Rezoning Transportation Analysis

Petition Number: #2022-099

Date	Description
11-28-22	First Review (IW)
12-22-22	Second Review (IW)
01-26-23	Third Review (IW)

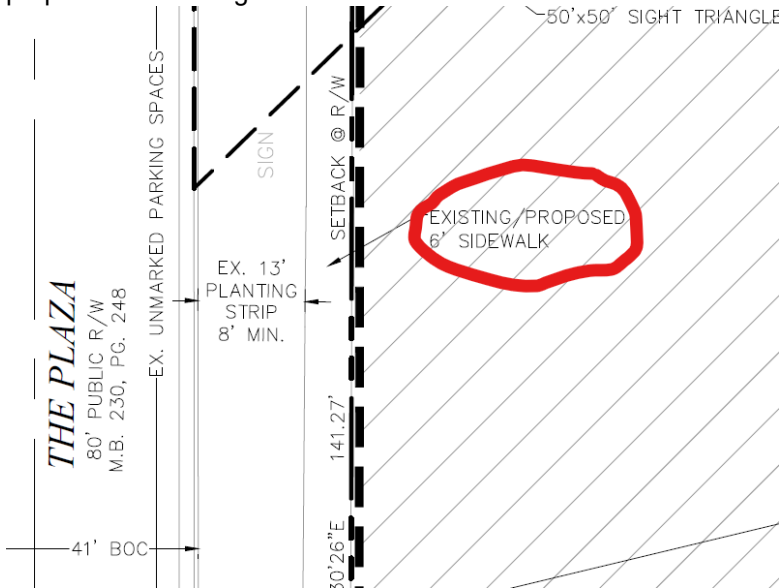
3. **Outstanding Comment from 11-28-22: Comprehensive Transportation Review (CTR):**

The Comprehensive Transportation Review was recently approved by City Council under the new UDO. In lieu of a TTM for the proposed site CDOT has requested the petitioner complete a CTR for the site. The petition's zoning falls within the medium to high intensity development which based on the 1,775 daily trips will trigger Tier 3 (14 mitigation points) for multimodal assessment and Tier 3 (6 mitigation points) for transportation demand management assessment.

The petitioner shall review and assess the publicly accessible pedestrian network within ¼ mile walking distance of the site to identify multimodal infrastructure to meet the Tier 3 (14 mitigation points) for multimodal assessment. Petitioner shall also provide transportation demand management strategies to meet Tier 3 (6 mitigation points) to reduce vehicle trips and encourage alternative modes of transportation.

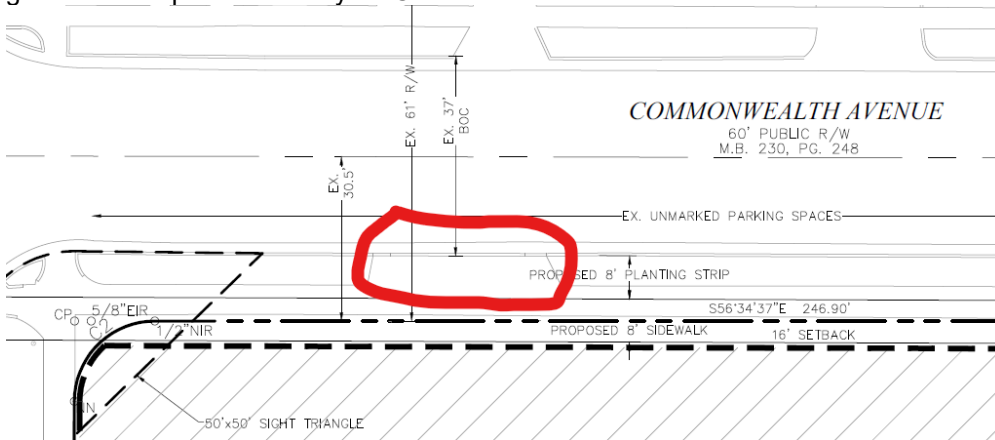
5. ~~Revise site plan and conditional note(s) to specify what portion of the sidewalk along The Plaza will be proposed vs existing.~~
